SUBJECT: **PMB-"RESTROOM ACCESSIBLITY AND PLUMBING UPGRADES ADA"-(REBID)**

SUBJECT: Police Memorial Building Restroom Accessibility and Plumbing Upgrades, ADA
BID# CP-0089-15
Contract 8565-09

ATTACHMENT "A"
ACCOUNT NUMBERS
POLICE MEMORIAL BUILDING RESTROOM ACCESSIBILITY AND PLUMBING UPGRADES ADA

System No. F-A-2045

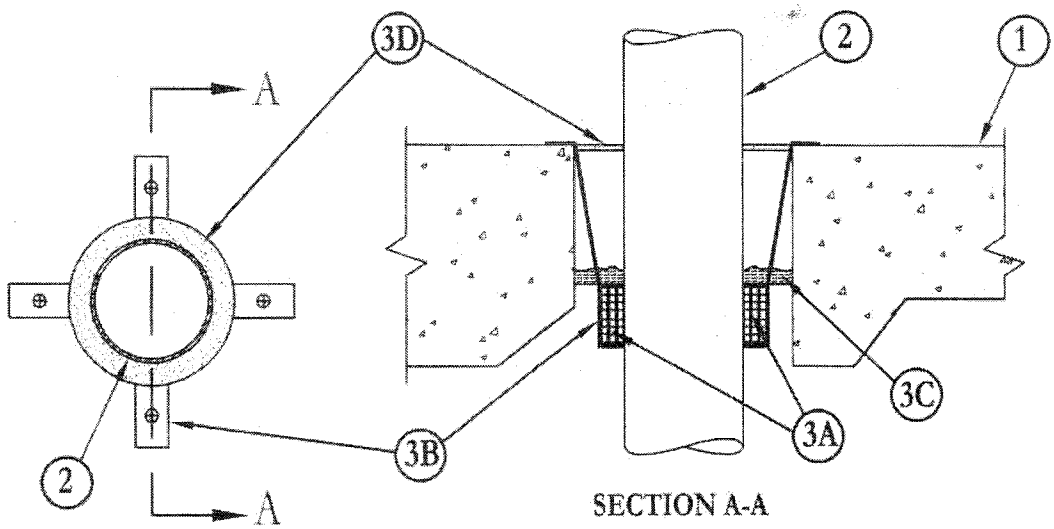
Per your field meeting with the building inspector, Robert Coulter, to review existing conditions, our understanding now is that Mr. Coulter is requiring "all existing penetrations and panels in the existing wall in East Phase 1 floor/ceiling be treated with a fire stop system. This is contrary to what we have been told was acceptable to pass inspection of existing "rated wall" inspection. Based on the field meetings with the 3M representative, the attached fire stop systems have been developed. Please review the following cost breakouts:

PARTIAL FLOOR PLAN - LEVEL 1 EAST

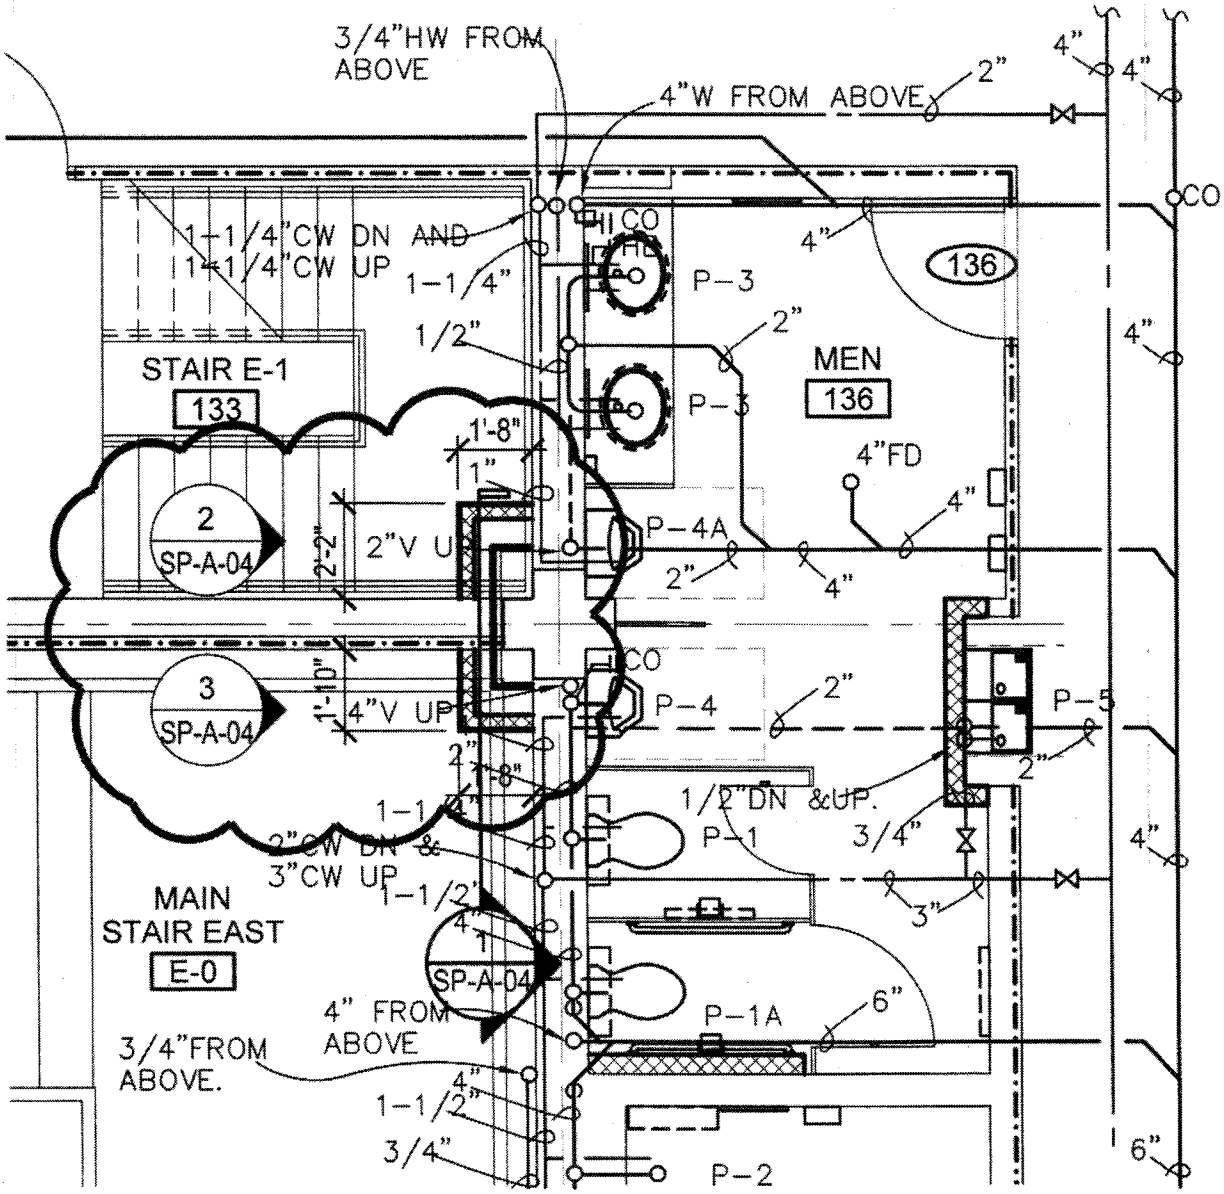
Pursuant to RFI #42; for the scope of work to add chase walls to conceal the new sewer layout; per the plans provided by VRL, Supplemental Drawing 1025-SP-A-03 & 1025-SP-A-04; including wall systems, patching as required, and painting in East Phase 1 stair way corridors; please review the following cost breakouts:
